CERTIFICATE OF APPROPRIATENESS

Property: 7707 Lakewind Street, tract 35, block 21, Glenbrook Valley Subdivision. The property includes a historic 3,469 square foot, one-story wood frame single-family residence and an attached garage situated on a 35,524 square foot interior lot.

Proposal: Alteration – Replace the existing wood cladding and four windows on a contributing residence

Recommendation: Partial Approval: Approve the siding replacement and deny the replacement of windows.

SIDING DETERIORATION DETAIL PHOTOS

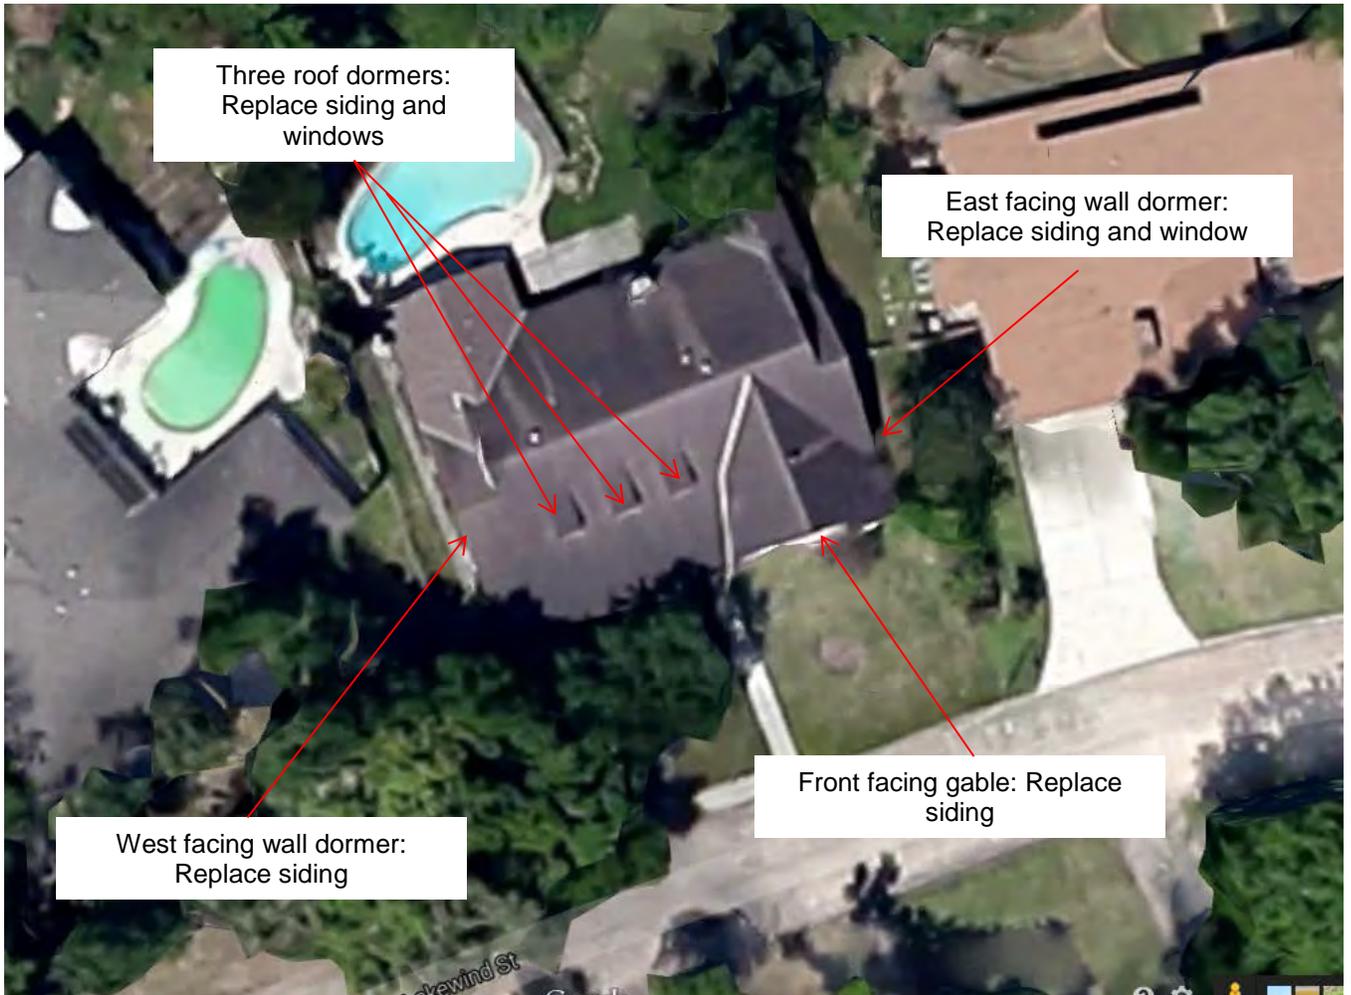
The applicant asserts that the existing wood siding has deteriorated beyond repair citing numerous examples of rot and splitting. Staff and the Structural Inspector confirmed this assertion during our site visit.

FLOOR PLAN

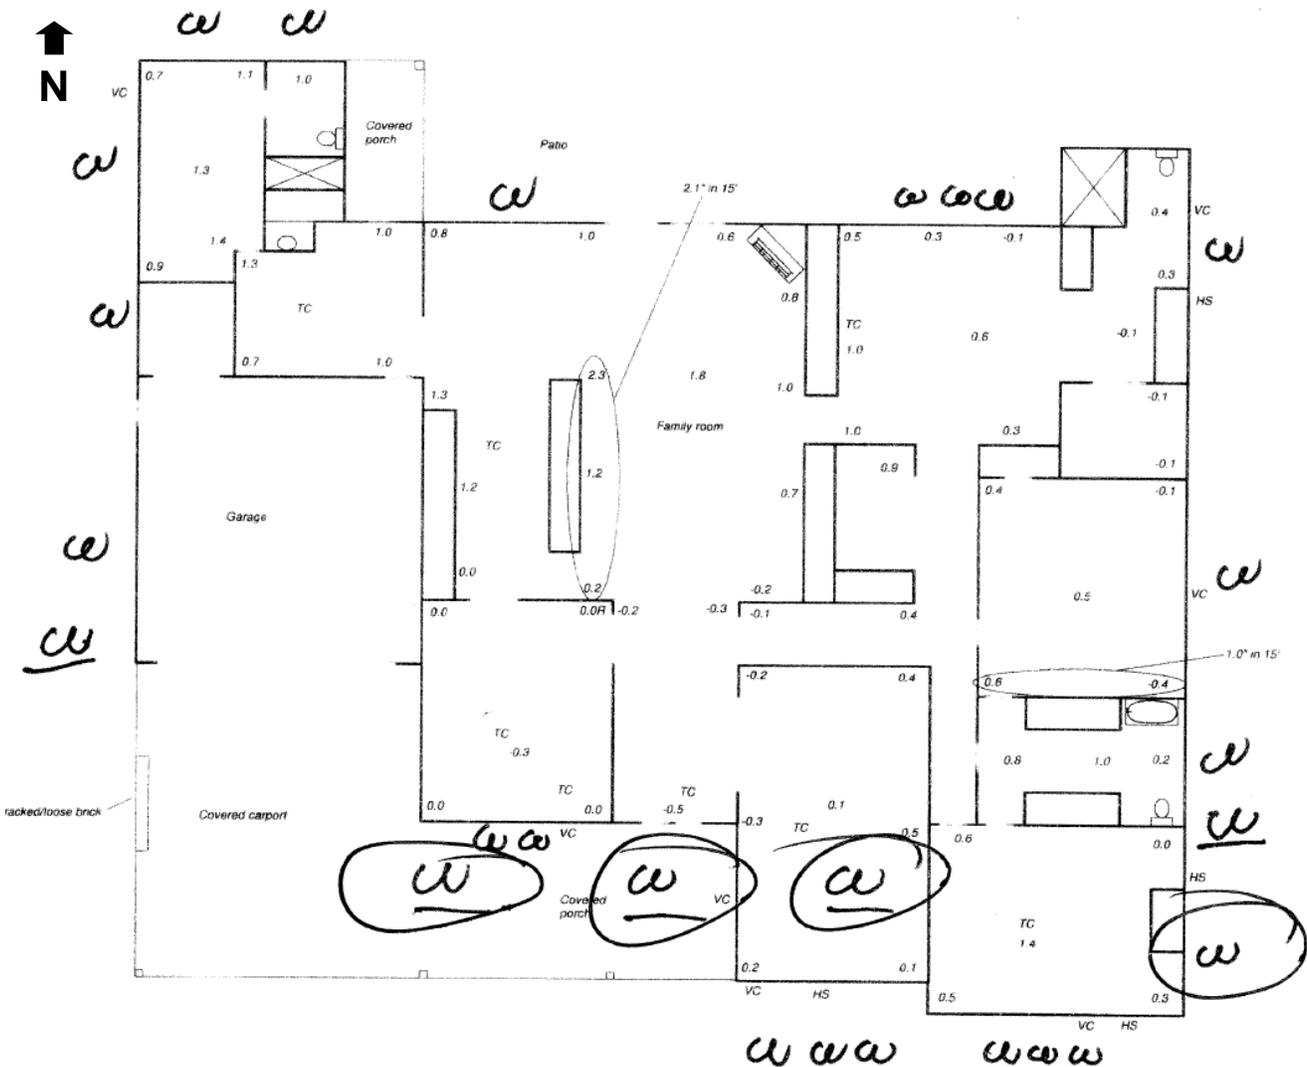
W - INDICATES WINDOWS AND CIRCLED W – INDICATES WINDOWS PROPOSED TO BE REPLACED

Windows/Doors: The applicant proposes to replace four pairs of original aluminum diamond shaped divided lite windows. Three of these pairs are located on the three front facing attic dormer and one is located on an east facing wall dormer.

Staff performed a site visit with the City's Structural Inspector to confirm the applicant's assertion that the windows are deteriorated to the point of being beyond repair. Staff found that the windows are operable and are not deteriorated to the point of being beyond repair.
